ADDENDUM NO. 1

**Rochester Housing Authority
Lena Gantt Roof and Siding Replacement, Phases I and II
HUNT 2285-044**

ADDENDUM NO. 1

January 12, 2017

3 ROOF STEP UNDERLAYMENT DETAIL (UP TO 2'-0" HIGH)
N.T.S.

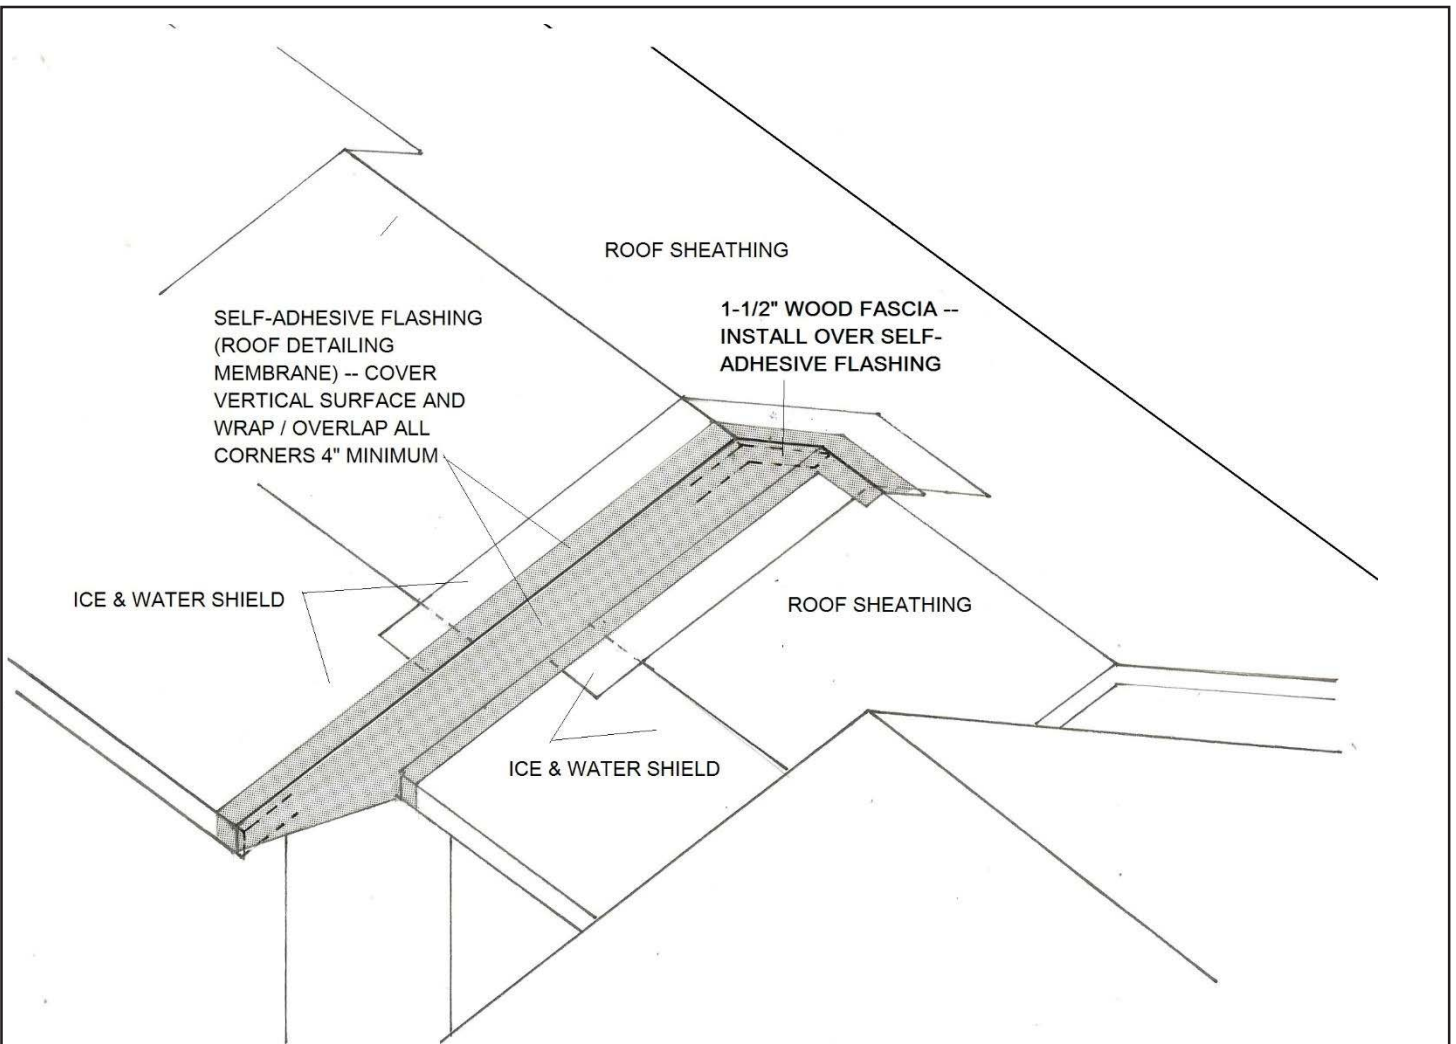
- AD1- 11 Add Drawing A1.2 (included in this Addendum) to the drawing set.
- AD1- 12 To Drawing A4.1: Delete detail 3/ A4.1 and insert Detail 3/ AD-1 (included in this Addendum) in its place.

- AD1- 21 Drawing A0.1, Construction Work Summary Notes; Delete note M and insert in its place: "Inspect and verify that roof ventilation path is unobstructed from soffits to attic spaces. Adjust obstructing insulation, if any. Document and review with Architect and Owner."
- AD1- 22 Drawing A0.2, Reference Notes; to note 8, Add: "Replace existing flue cap with Selkirk/ Metalbestos High-Wind Cap; size as appropriate for existing pipe diameter."
- AD1- 23 Drawing A0.2, Reference Notes; Add note "20. Temporarily remove conduit and electrical devices. Reinstall upon project completion (Typical)."
- AD1- 24 To Drawing A4.1: Delete detail 3/ A4.1 and insert Detail 3/ AD-1 (included in this Addendum) in its place.
-

AT ROOF TRANSITION LOCATIONS:

1. PROVIDE ROOF SHEATHING AS REQUIRED.
2. INSTALL ONE LAYER OF PLYWOOD WALL SHEATHING OVER EXISTING (OR REPLACEMENT) GYPSUM SHEATHING.
3. APPLY ICE & WATER SHIELD TO SLOPED SURFACES AS SHOWN / SPECIFIED.
4. APPLY SELF-ADHESIVE FLASHING TO WALL SHEATHING AND ALL CORNERS.
5. INSTALL 1-1/2" WOOD FASCIA AND COVER / WRAP TOP CORNER WITH ADDITIONAL STRIP OF SELF-ADHESIVE FLASHING.
6. INSTALL FELT, DRIP EDGE, STEP FLASHING, SHINGLES & MISC.
7. INSTALL ALUMINUM FASCIA CLADDING.
